## Department of Permitting and Inspections

## MEMORANDUM

**To:** The Design Advisory Board  
**From:** Mary O'Neil, AICP, Principal Planner  
**RE:** ZP21-0358CA/CU; 40 Kingsland Terrace  
**Date:** October 27, 2020, **November 24, 2020**

**File:** ZP21-0358CA/CU  
**Location:** 40 Kingsland Terrace  
**Zone:** RL **Ward:** 6S  
**Parking District:** Neighborhood  
**Date application accepted:** October 1, 2020  
**Applicant/ Owner:** Katie Menson, Kellen Brumsted  
**Request:** Demolish existing garage; construct new garage with 616 sf. Accessory Dwelling Unit (ADU.)

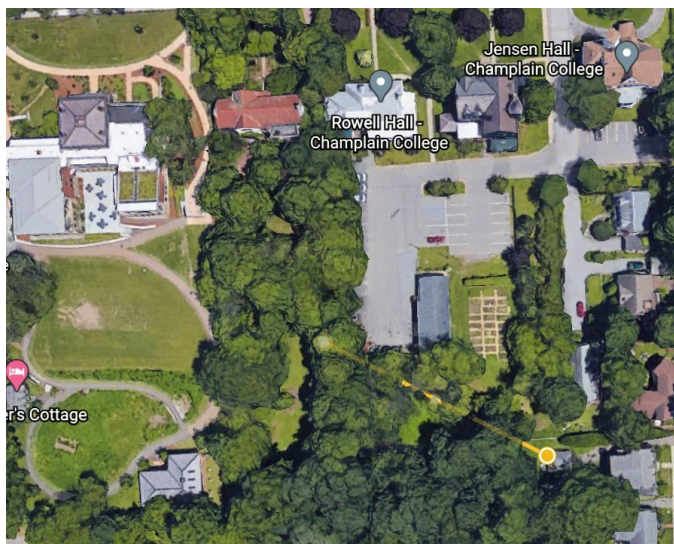
The associated civil plans reflect an instrument granted by 267 South Willard Street owners to allow Champlain College a 15' wide easement allowing stormwater infrastructure to pass over their lot and connect with another Champlain property at 275 South Willard Street. It must be noted that this agreement in no way affects 40 Kingsland Terrace and, in fact, is located some

230+ feet away from the subject garage. There is no identifiable link between the function of the stormwater easement and the property at 40 Kingsland Terrace. Staff finds the materials unrelated and insufficient evidence to warrant consideration of a variance to a required rear yard setback for a replacement structure at 40 Kingsland Terrace.
